Receive a staff presentation and hold a Public Hearing to receive comments for or against Resolution 2025-XXR, granting a request in Case No. AC-25-02 for Alternative Compliance to the maximum building height requirements in Section 4.4.3.7 of the Development Code to increase the permitted building height from five to seven stories, for a proposed development generally located between W. Hutchison St. and Pat Garrison St. between N. Comanche St. and N. Fredericksburg St.; authorizing City staff to issue permits consistent with this resolution; and declaring an effective date; and consider approval of Resolution 2025-XXR.

AC-25-02

#### **Downtown Gateways**

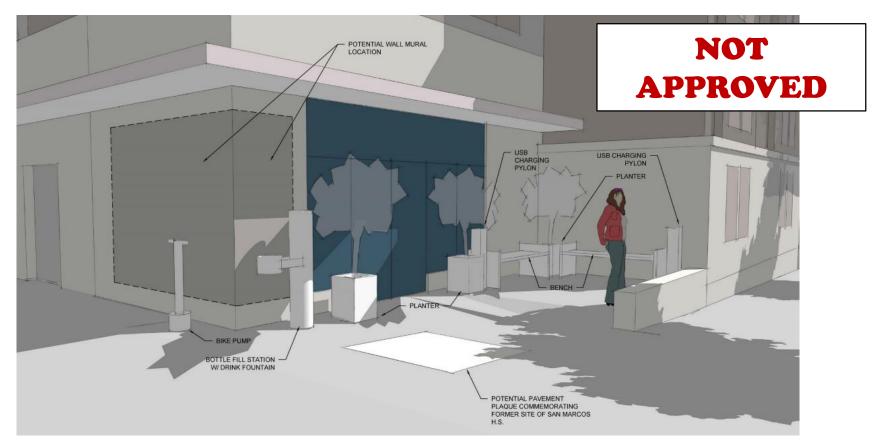
- Pat Garrison St./ Comanche St. intersection is designated as a Pedestrian Gateway
- Recommendation D.7 (p. 91)
   "Create vehicular, multimodal, and pedestrian gateways into Downtown to provide an arrival experience and increase sense of place..."

#### **Table 1.1: Height Strategy by Context**

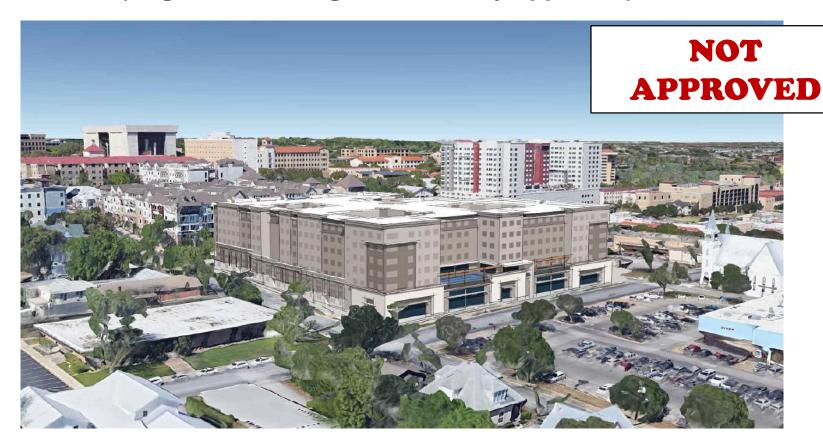
Downtown Core/ Additional Height in the Third Layer

"No additional height adjacent to the Downtown Historic District. Additional height may be considered where it will not obscure key views, but additional height above five stories is discouraged in this design context." (p. A:10)
